Production Change Notification

Panasonic Batteries

Nature of Change:
Packaging Change

Affected Model:
HHR-20SCPY, HHR-25SCHY03, HHR-30SCPY20,
HHR-330AHY01

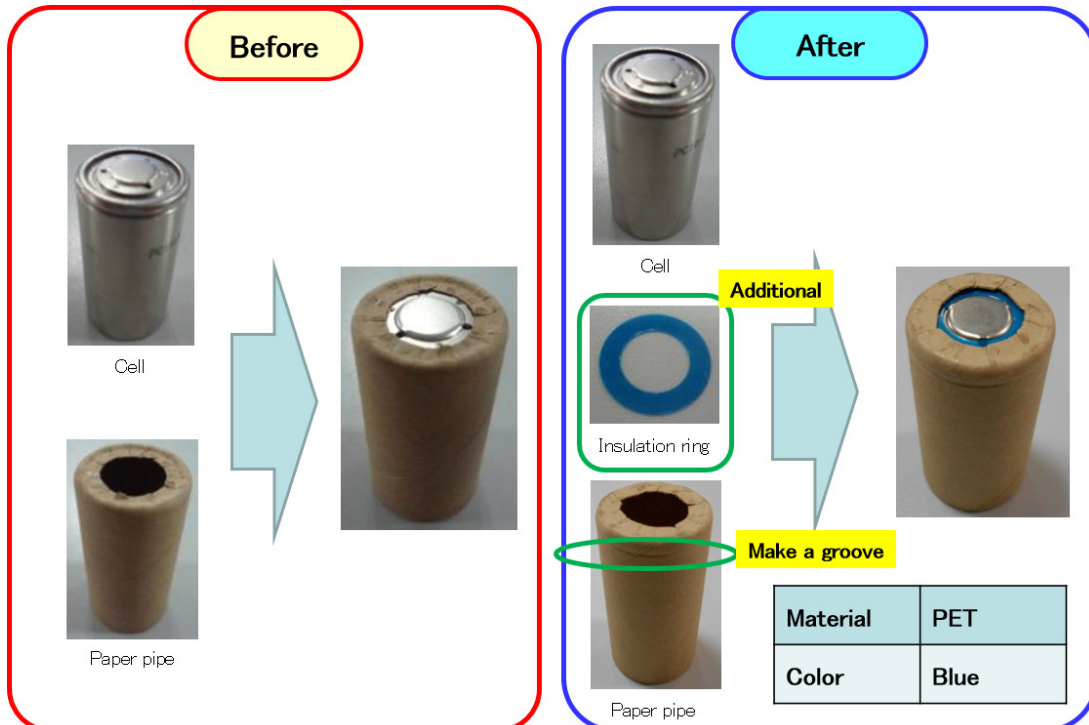
Panasonic Energy Corporation will be adding an additional upper insulation (Material: PET) on the NiMH Sub C part numbers. With this change a groove will be added in the paper pipe to prevent movement. The performance, size, and quality of the battery will not be changed. The factory will be making this change immediately.
